Figure for Comment 154

IEEE P802.3cg 10 Mbps Single Pair Ethernet
Task Force Draft 1.1 Task Force Review

Figure 147-11—Multidrop line termination and PMD

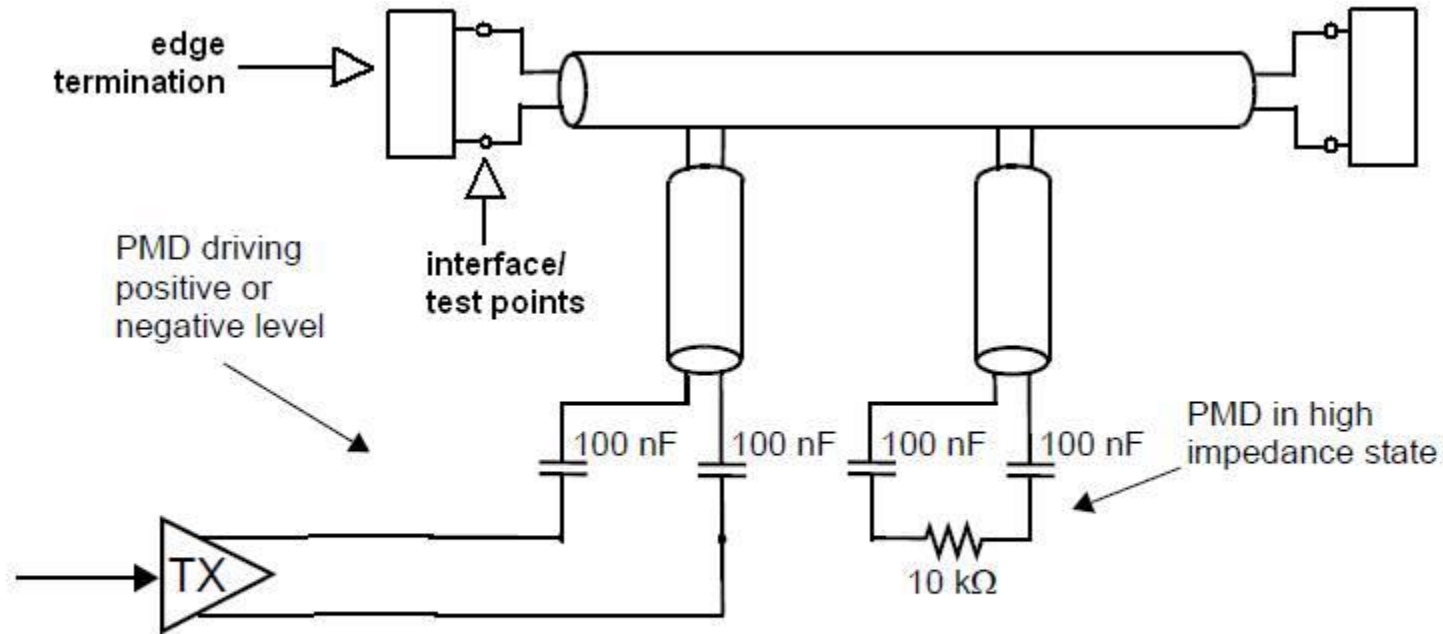
Markup of Figure 147-11
